UtahAmerican Energy, Inc.

Re: UtahAmerican Energy, Inc. Lila Canyon Mine, ACT/009-013, Response to Chapter 7
Water Monitoring Deficiencies 11-012

Deficiency List

Task Name Water Monitoring Revisions

Little Park Wash Photographs

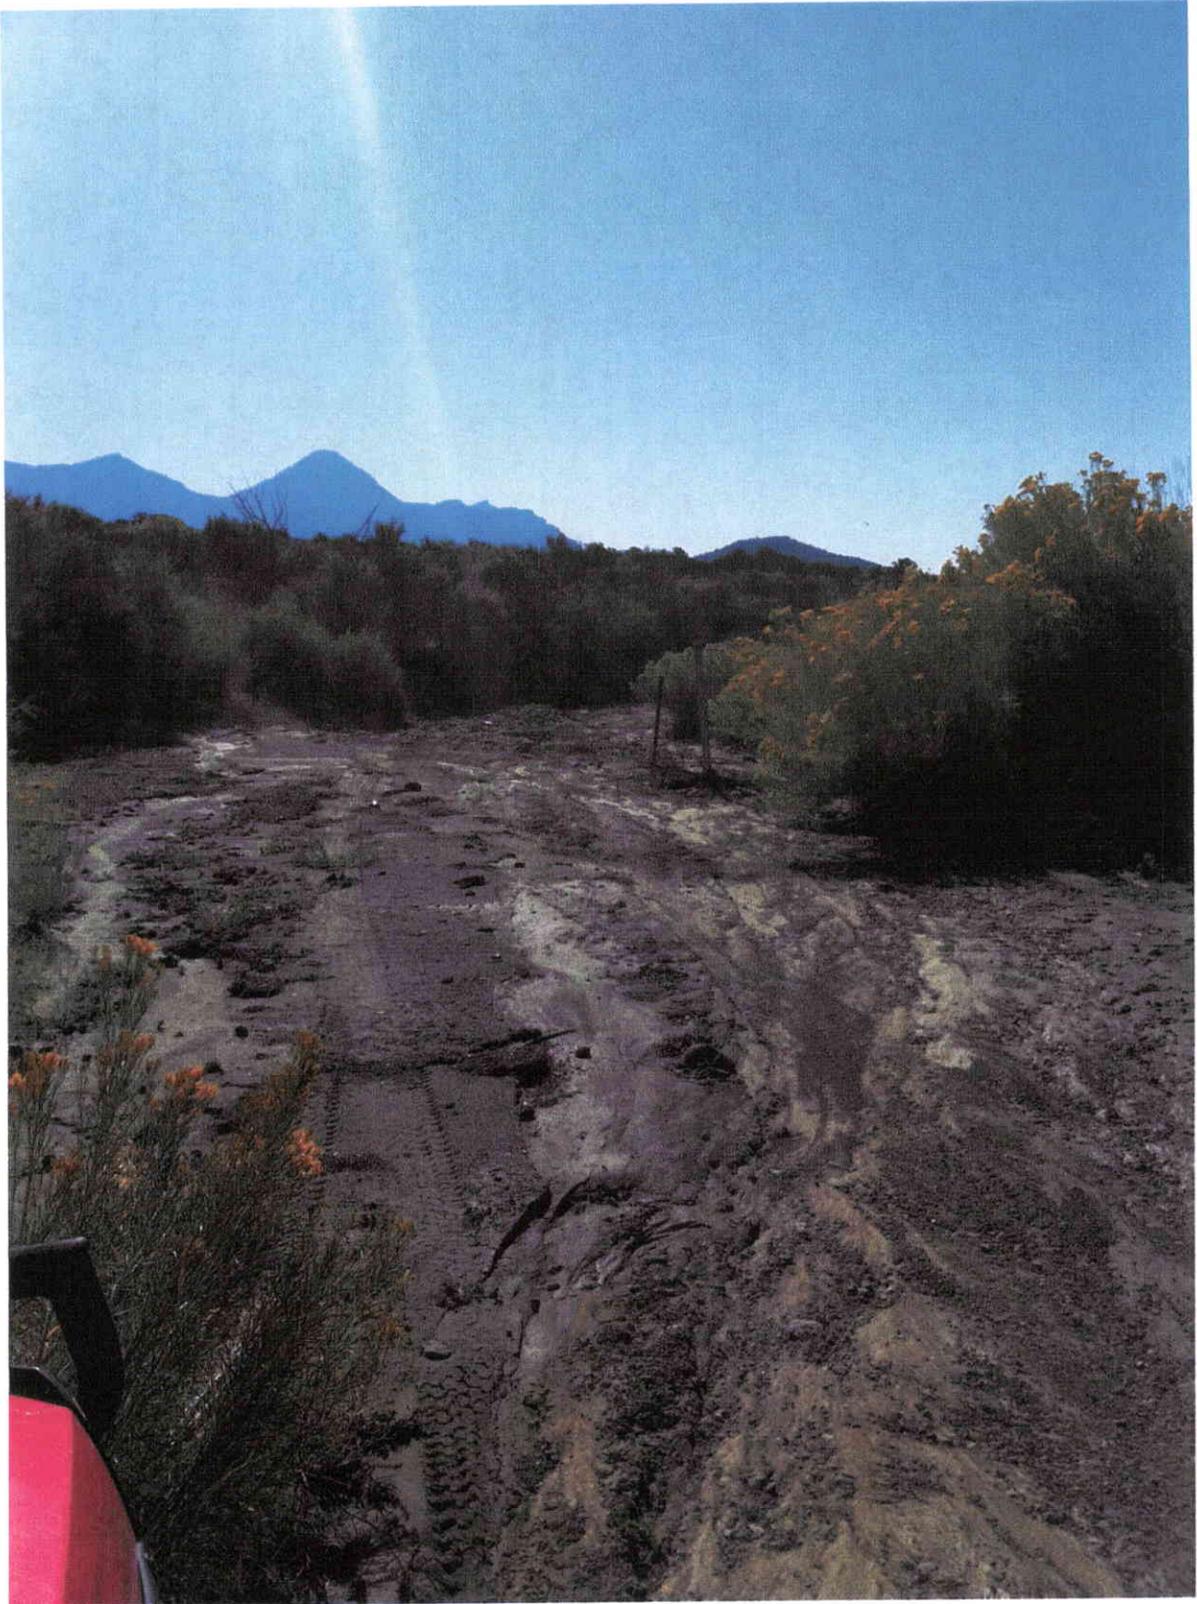
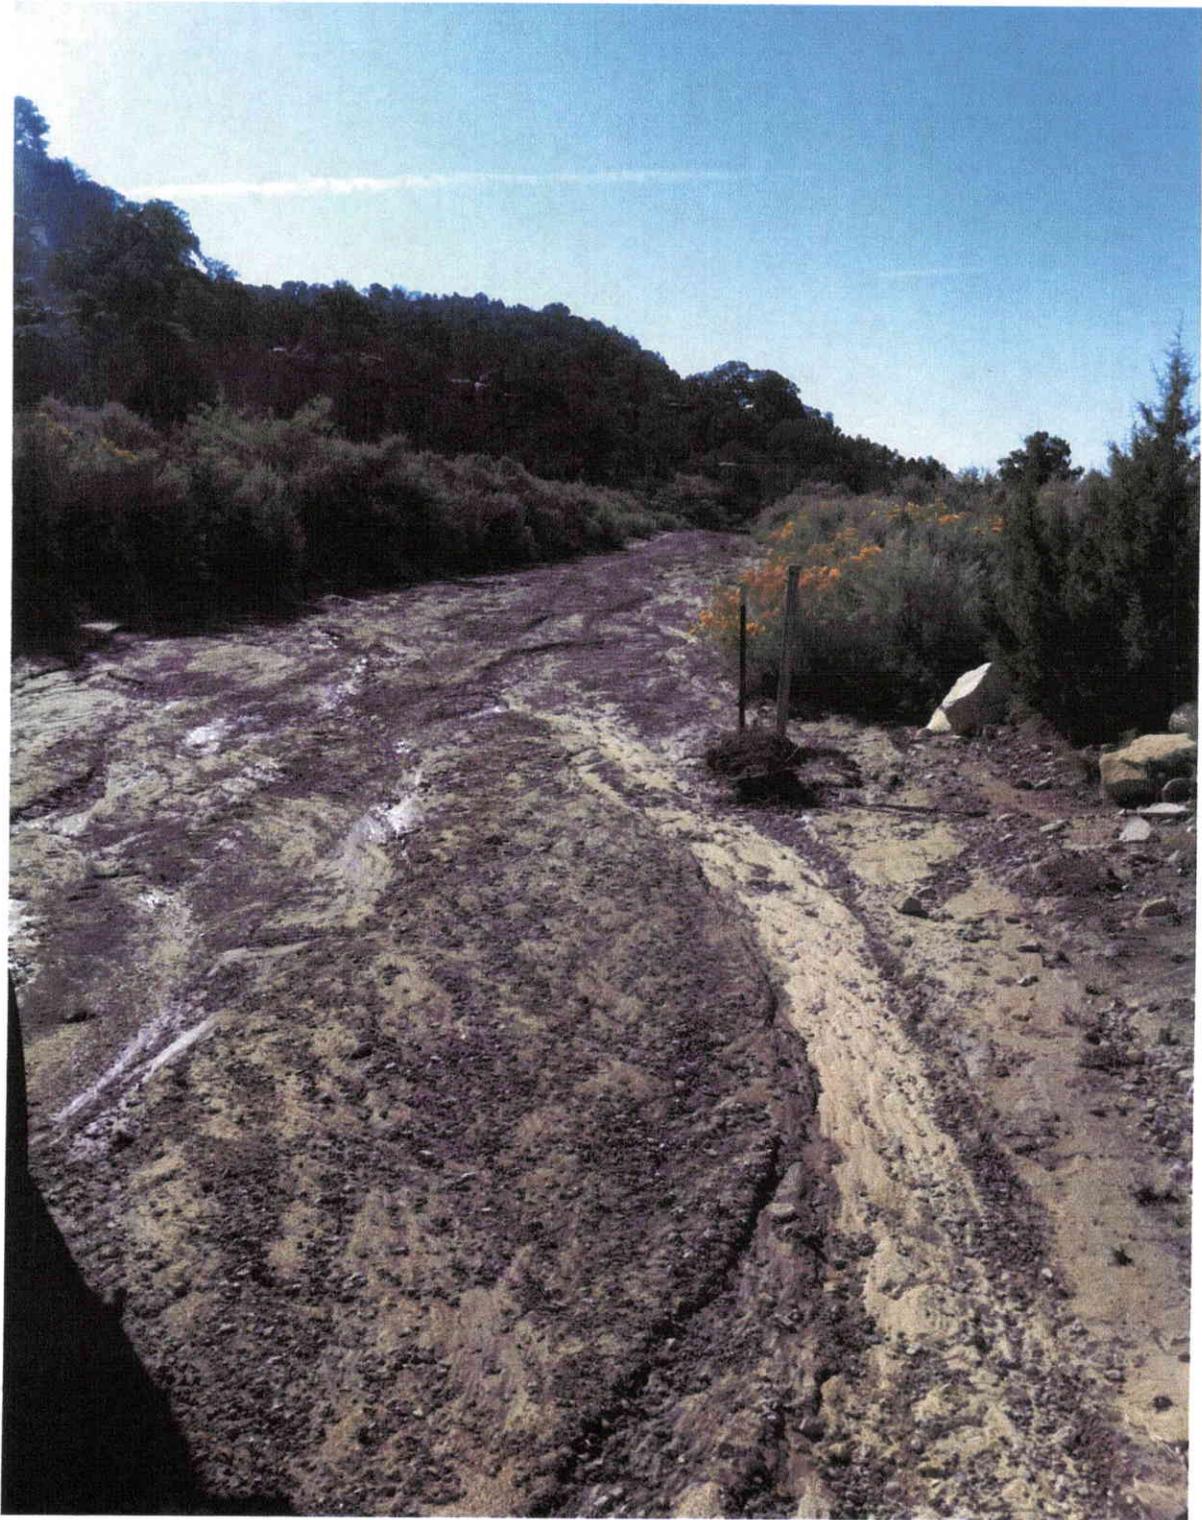
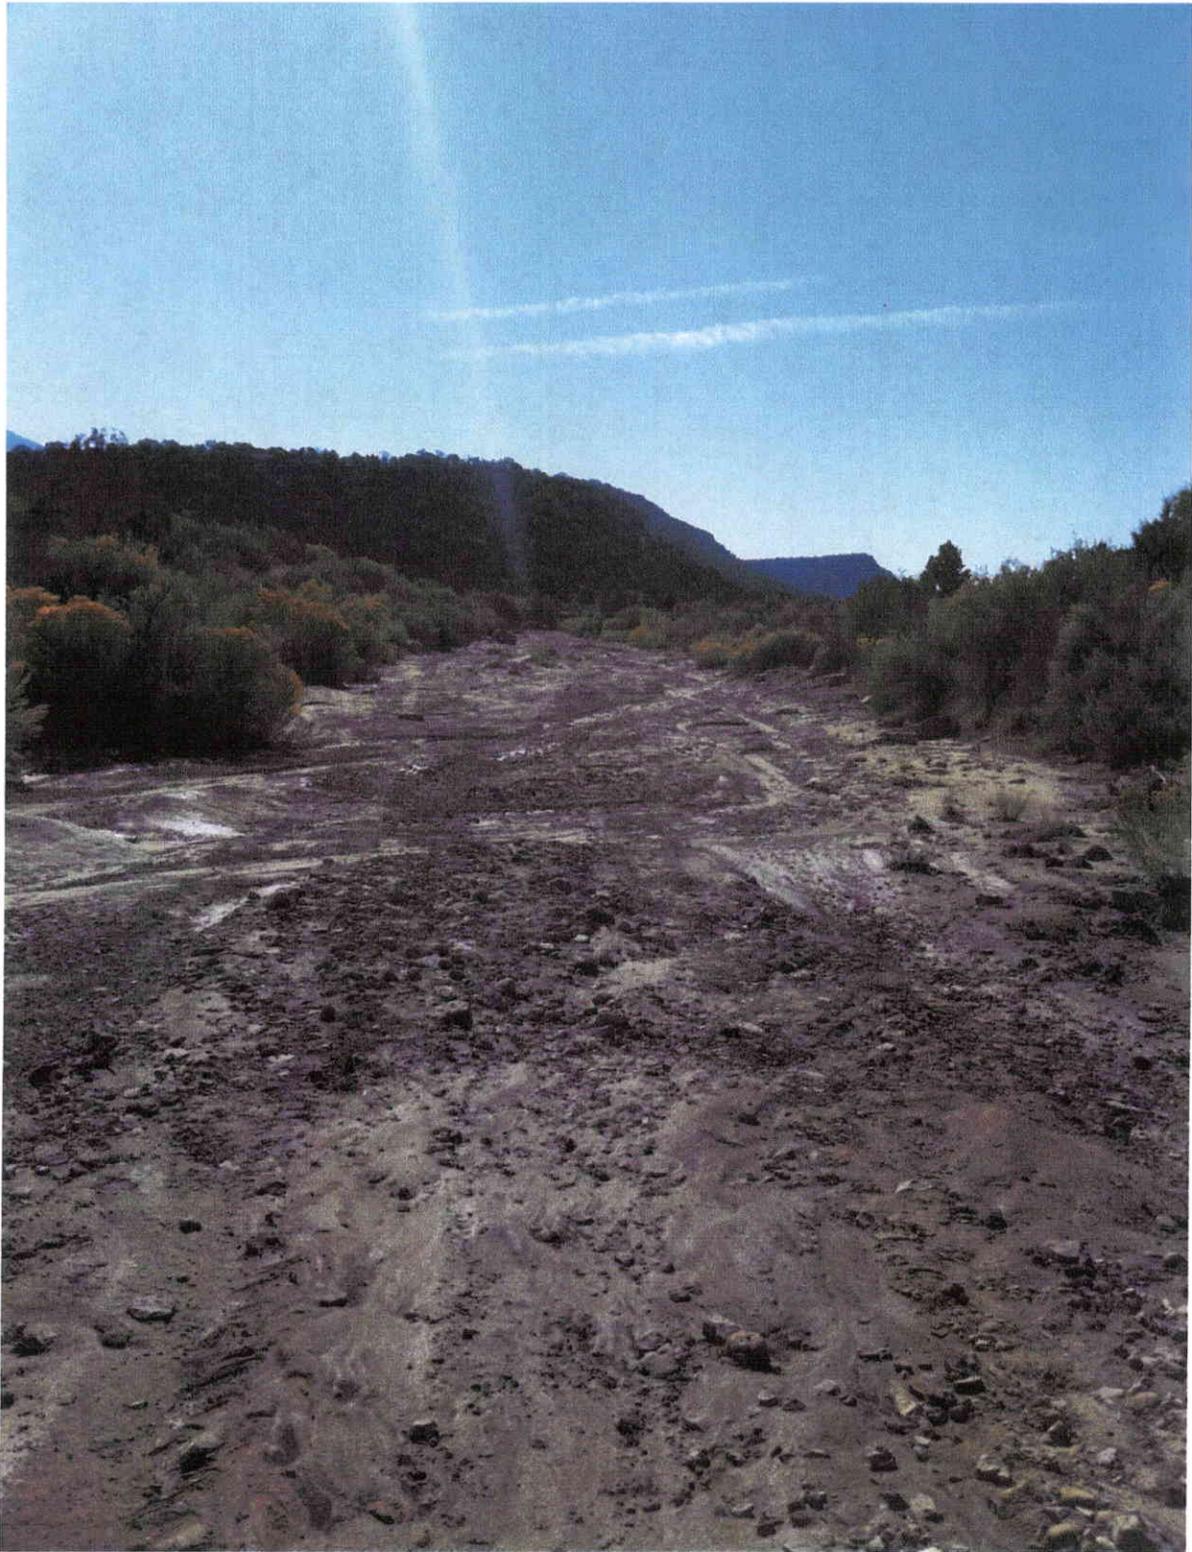
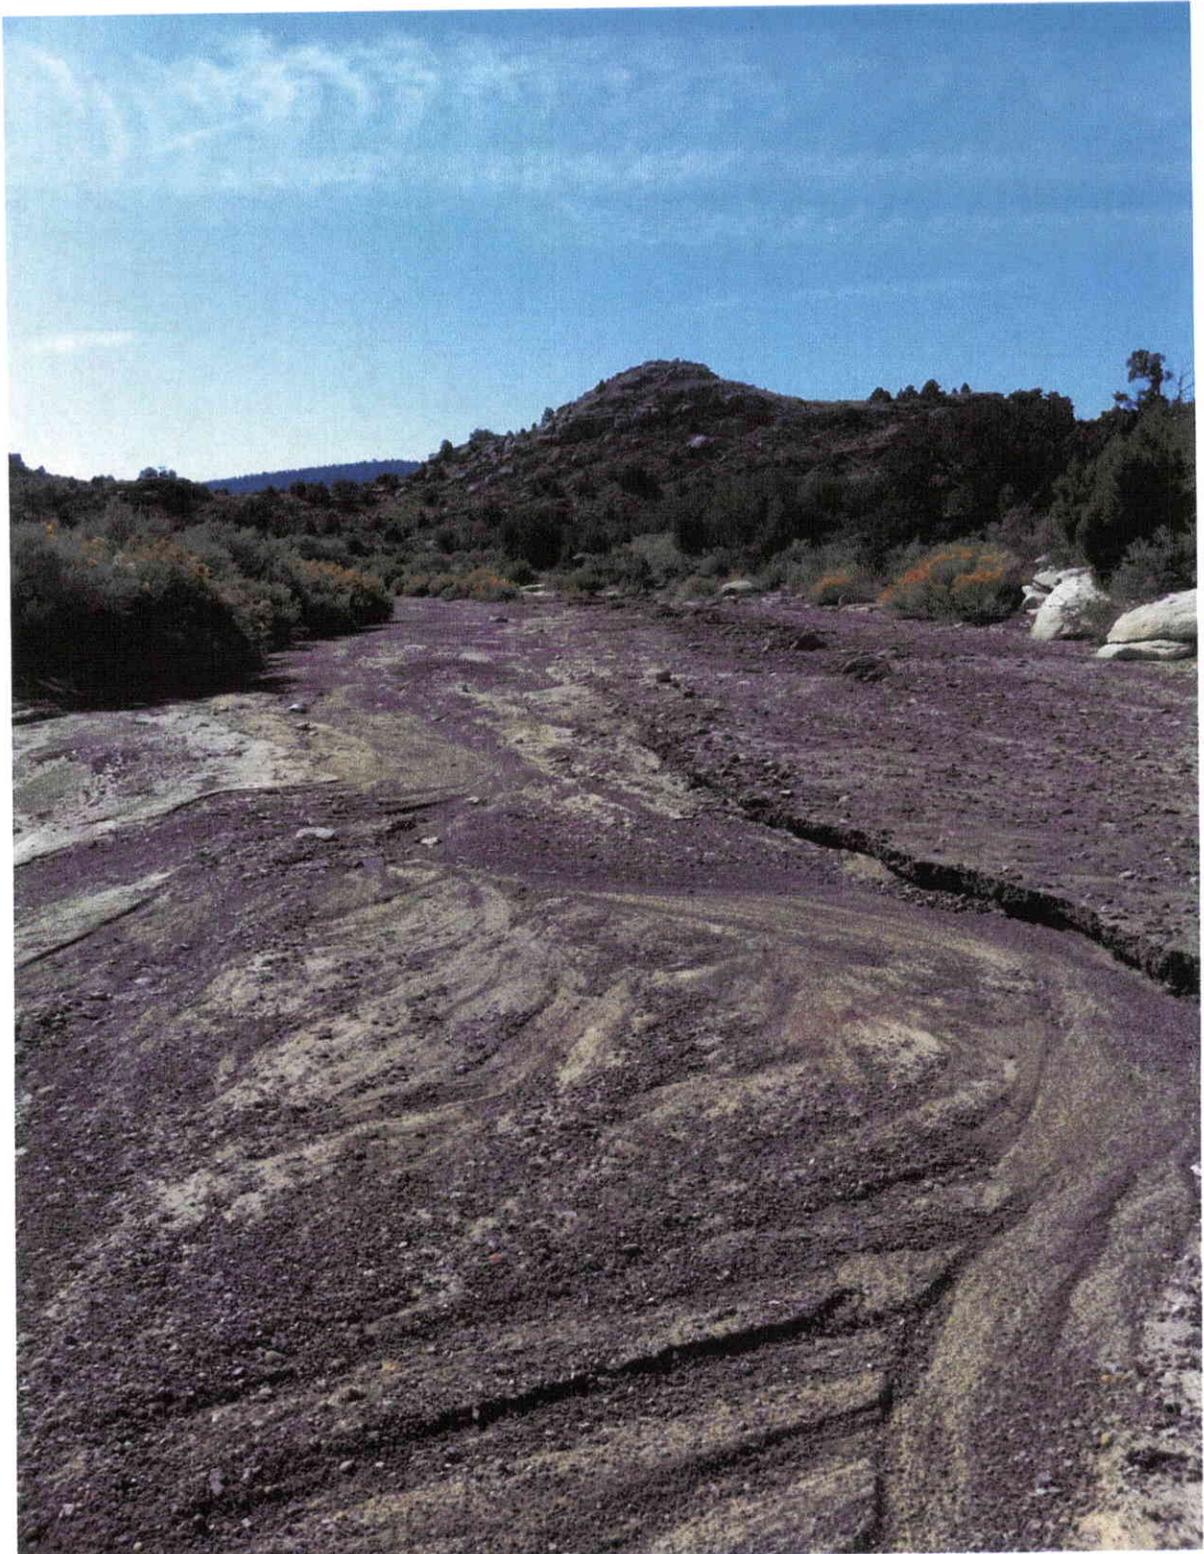
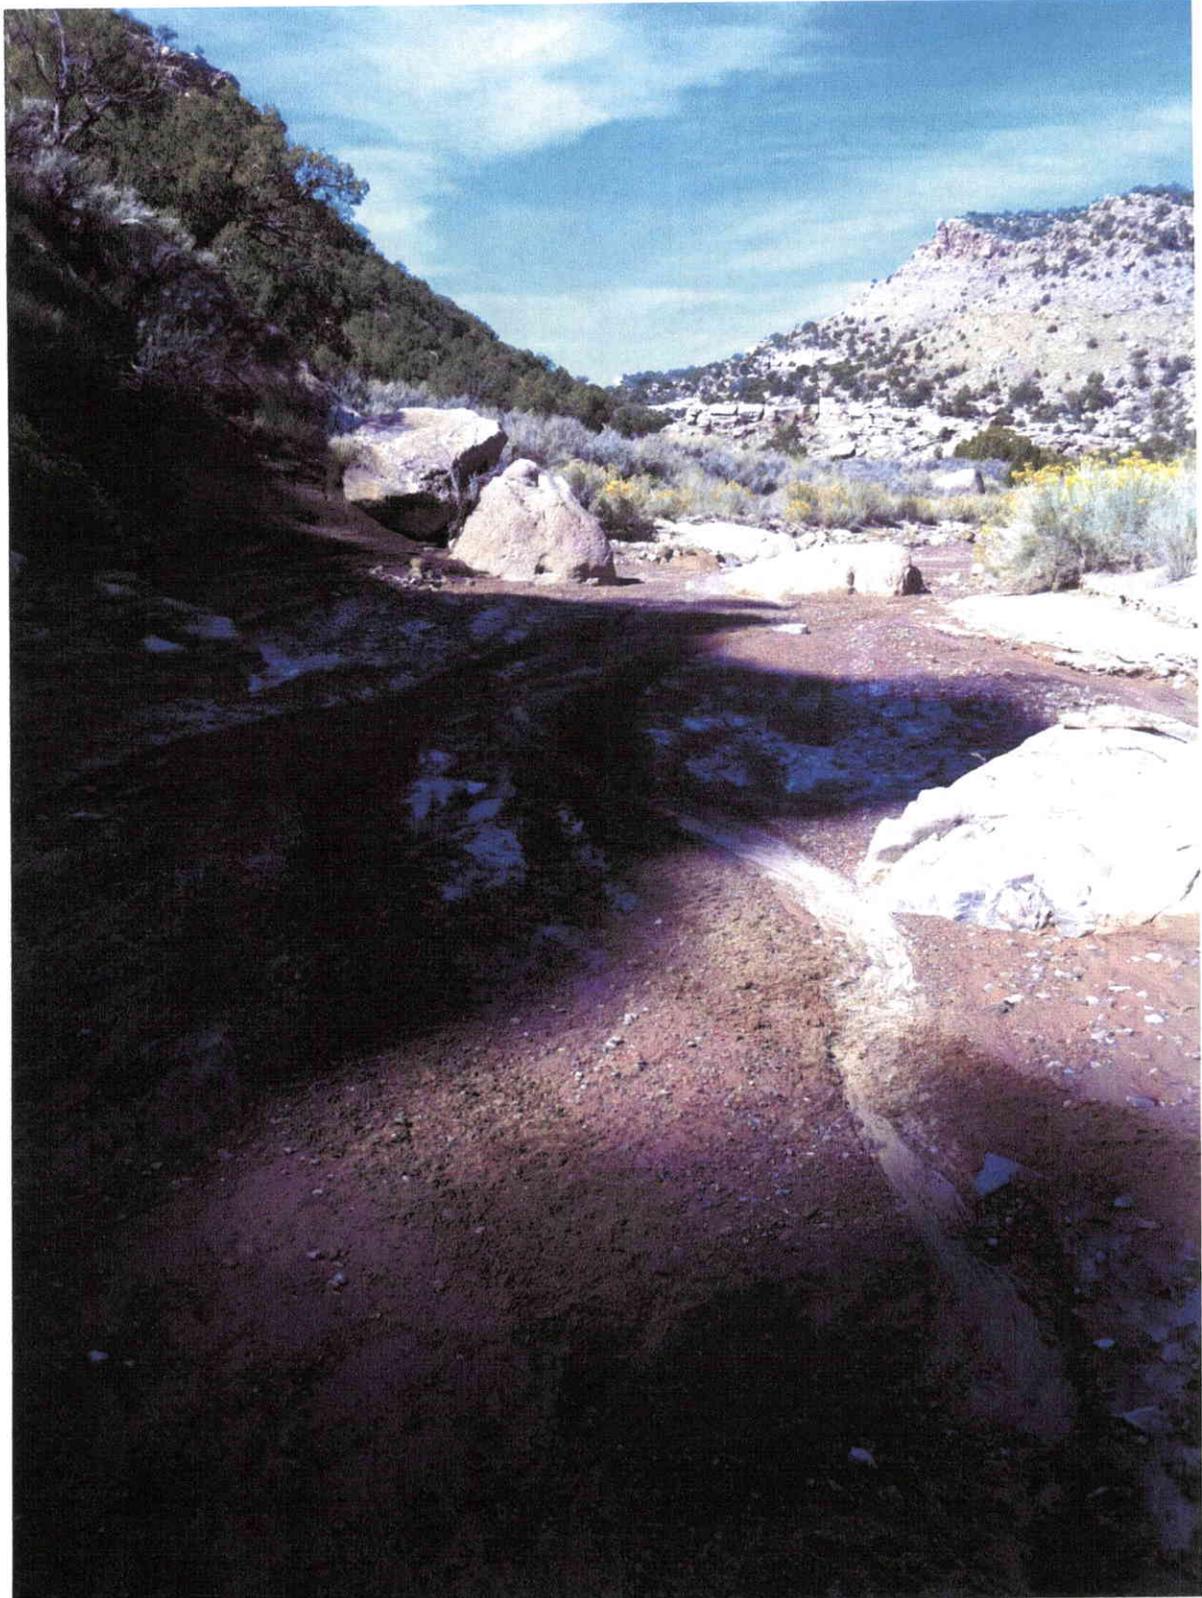
[R645-301-731.200]: *The technical memo issued by Jim Smith on June 7, 2011 indicated that L-19-S will remain active to monitor Little Park Wash at the permit boundary. The resubmitted Table 7-3 indicates that L-19-S will be temporarily suspended from the monitoring plan. The Permittee needs to resolve this discrepancy and confirm whether or not L-19-S is intended for temporary suspension from the water monitoring plan. Also, Plate 7-4 shows this monitoring location as inactive.*

It has been suggested that the site for L-19-S be shifted to a location down channel where the confluence of other streams might result in a better sampling location. UEI believes that there is no benefit to adjust this location. The condition of Little Park Wash is consistent as a mobile bed channel along its entire length through the project area. Photographs of the channel from the road crossing of the channel to the confluence with Greasewood Creek. These photographs are attached. They show a consistent channel condition and general channel shape along its entire location. Figure 1 shows the locations of each of these photographs.

Due to the above discussed difficulties, UEI does not believe that additional sampling of L-19-S will serve any additional purpose. Therefore, UEI still requests that sampling of L-19-S, along with all other surface water sites away from the surface facilities, be temporarily suspended until the two year period prior to second mining. Plate 7-4 shows the temporary suspension status of the various sites requested.
